Consultant	Wahib Medanat Consultant Engineer	Rep No.	13-16022022
Contractor	Derar Saraireh & Sons for Engineering & Contracting	Tender No.	(11/2019/USAID/SKEP/3/S) Schools for a Knowledge Economy Project (SKEP) - Phase (3) Package (1, 2)
Site Name	Khadija Bint Khwailed Basic Mixed School- Shouna Janoubia	Day/ Date	Wed. 16/02/2022
Duration of Project	450 Calendar Days	Total Project Budget	9,789,417.840 JD

Visit Notes

(Figure: 14)

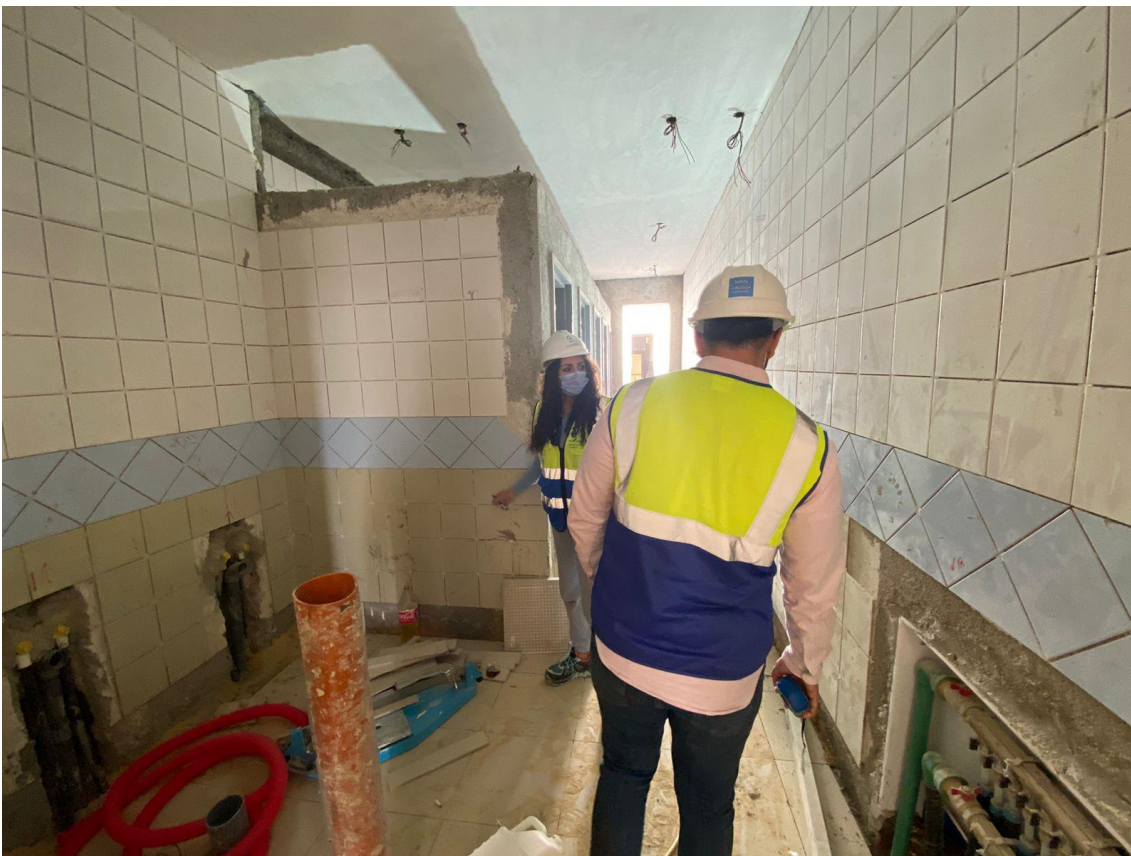
Inspecting the execution of wall tiles
